Errata

F²MC-16LX
16-BIT MICROCONTROLLER
MB90570 Series
HARDWARE MANUAL

Addendum, MB90570 Hardware Manual (CM44-10102-8E)

Power-On Reset

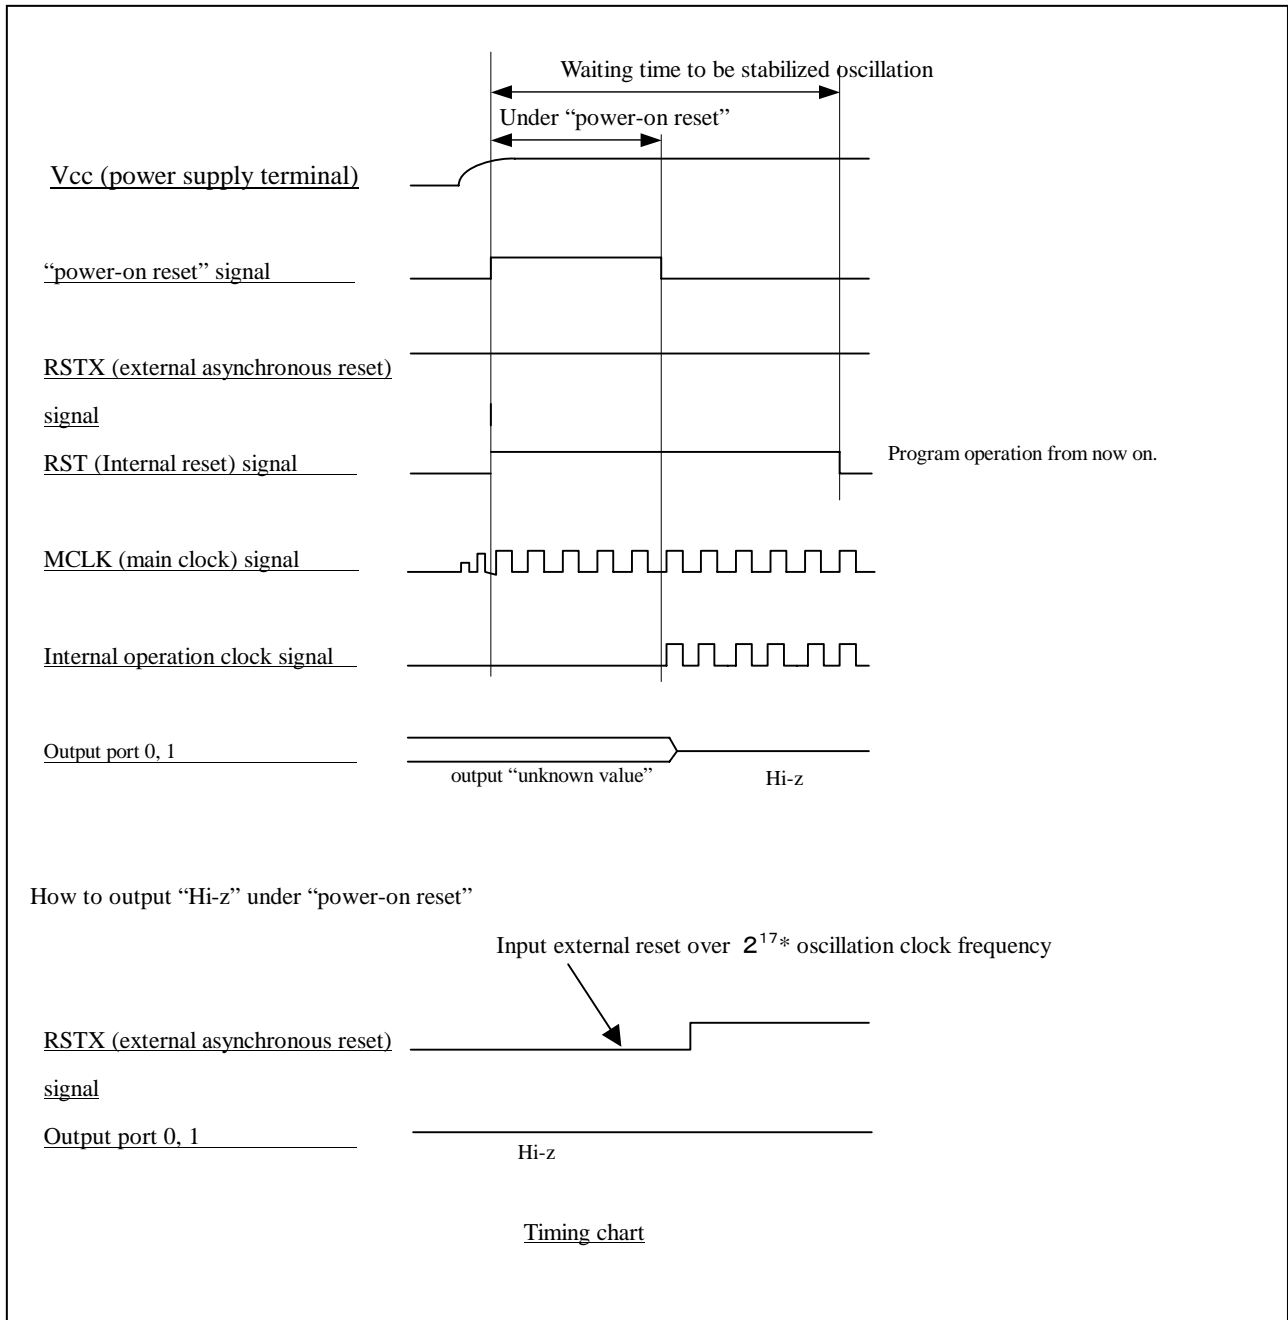
Output "unknown value" of pin 00 to pin 7 and pin 10 to pin 17 terminal, when the power supply Is turned on.

Pin 00 to pin 07 and pin 10 to pin 17 terminal become "unknown value" (output "H", "L" level or output "Hi-z") under "power-on reset" (stabilized times (2^{17} * oscillation clock frequency) of clamping circuit for internal power supply), when the power supply is turned on, and when "power-on reset" function operates and RSTX terminal is "H" level.

If you want to output "Hi-z" under "power-on reset", it is applied reset input " "L" level " from external and so pin 00 to pin 07 and pin 10 to pin 17 terminal become "Hi-z" condition during the time.
